## V2500 Nacelle Systems Modification SERVICE BULLETIN

Subject: Service Bulletin V2500-NAC-71-0266  
Revision 2 , Dated September 30, 2009

### NACELLE – INLET COWL – T.A.I. EXHAUST ACCESS PANEL – REPLACEMENT OF

**Removal and Installation of the T.A.I Exhaust Access Panel.  
Figure 1 (Sheet 1 of 1)**

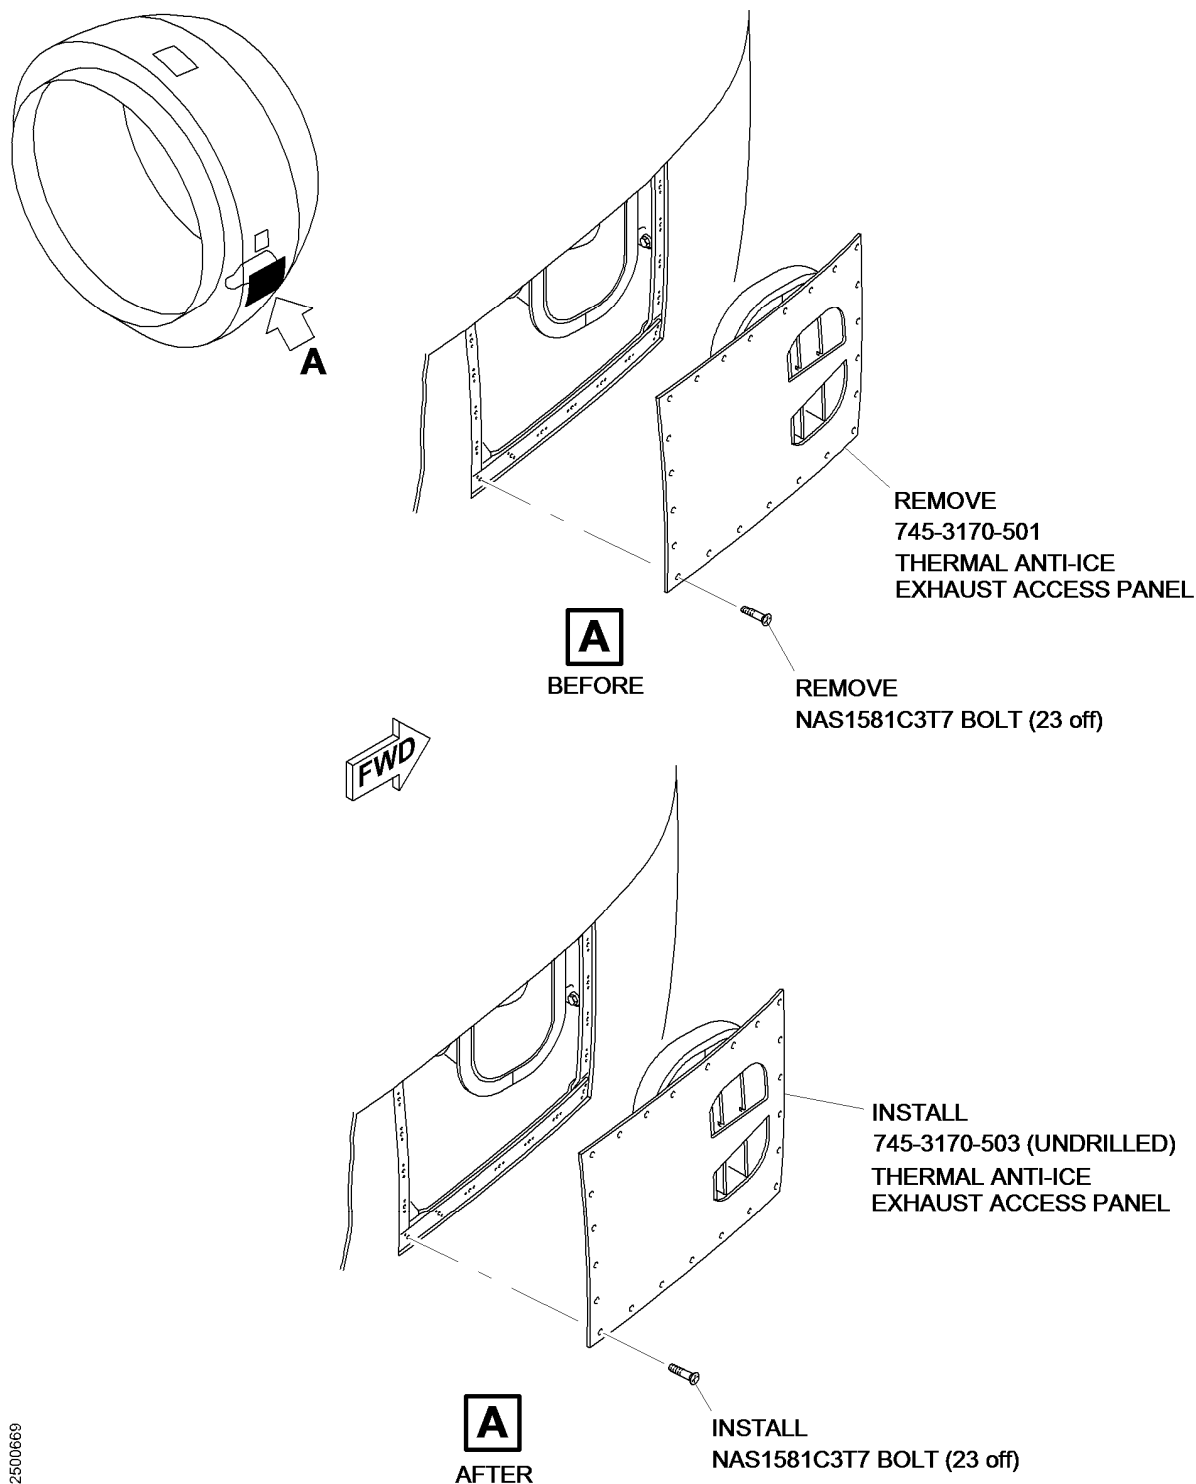
- (1) 2.B 'Parts affected by the bulletin' revised to remove reference to part number 745-3170-503U and to include disposition code 'C' for part number 745-3170-503.
- (2) 3.B 'Rework Instructions' step (2) revised to read '745-3170-503 (undrilled)'.
- (3) 3.B 'Rework Instructions' steps (3), (8), (10), (13) and (17) revised to read '745-3170-503'.
- (4) 3.B 'Rework Instructions' Figure 1 revised to read '745-3170-503 (undrilled)'.

- (1) Remove 23 off NAS1581C3T7 Bolts to release the 745-3170-501 T.A.I. Exhaust Access Panel. Remove the T.A.I. Exhaust Access Panel from the Nose Cowl. Refer to Figure 1.
- (2) Make a mark of the hole pattern on the new 745-3170-503 (undrilled) T.A.I. Exhaust Access Panel identical to the hole pattern of the attaching locations on the Inlet Cowl (use the removed T.A.I. Exhaust Access Panel as a template).
- (3) Drill 23 off pilot holes 3/32" (2.4 mm) diameter through the 745-3170-503 T.A.I. Exhaust Access Panel.
- (4) Enlarge the pilot holes to 0.2047" +0.003" / -0.000" (5.20 mm +0.0762mm / -0.000mm) diameter on the T.A.I. Exhaust Access Panel.
- (5) Countersink the 23 off holes on the outer surface of the T.A.I. Exhaust Access Panel to suit NAS1581C3T7 Bolts. Remove all burrs from holes.

- (15) Wipe the area with a clean piece of lint free cloth before the solvent dries.
- (16) Remove any unwanted jointing compound.
- (17) Install the 745-3170-503 T.A.I. Exhaust Access Panel with 23-off NAS1581C3T7 Bolts. Torque the bolts to 26 lbin (3.0 Nm).
